Source:	Prestolite Electric Ltd - Greenford, London, UK
Date:	February 9, 2016
Bulletin No:	TSB4066 rev.1
Models:	M100R Starter motors
Subject:	REPLACING AGRICULTURAL STARTERS

M100R STARTERS INSTALLATION

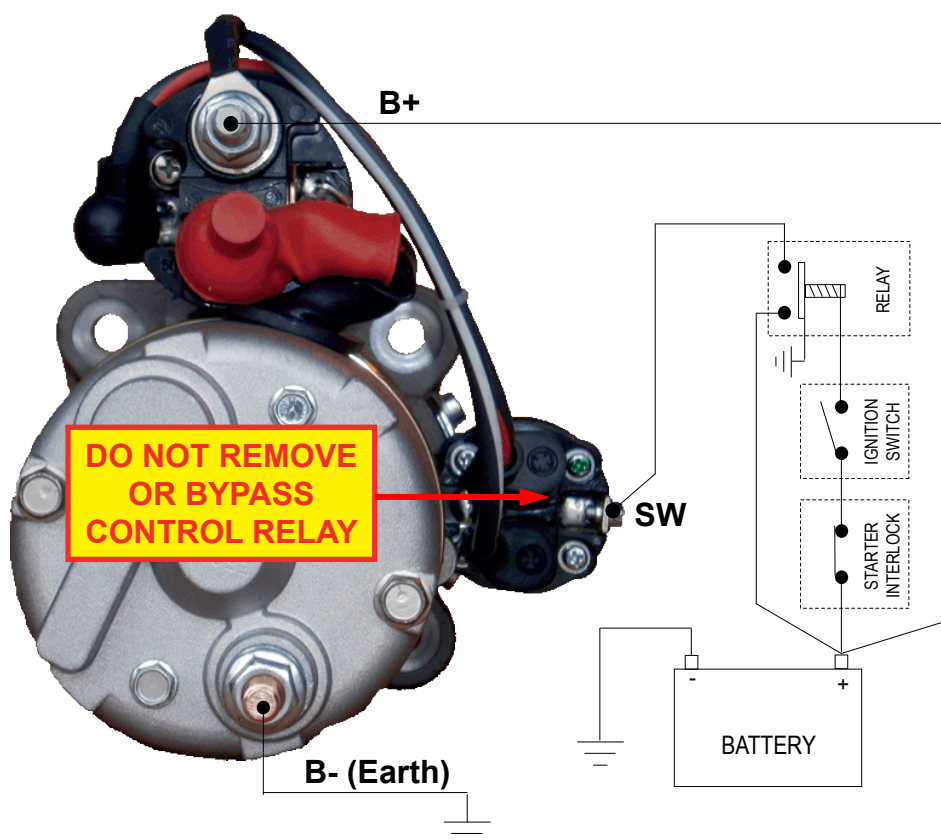
However, it must be noted that the M100R type starter motors are fitted with an additional small control relay, which is not present on OE starters.

The purpose of this control relay is to facilitate soft start engagement, protecting the ring gear.

Under no circumstances must the control relay be electrically disconnected or bypassed, it is integral to the starter functionality.

See wiring diagram below.
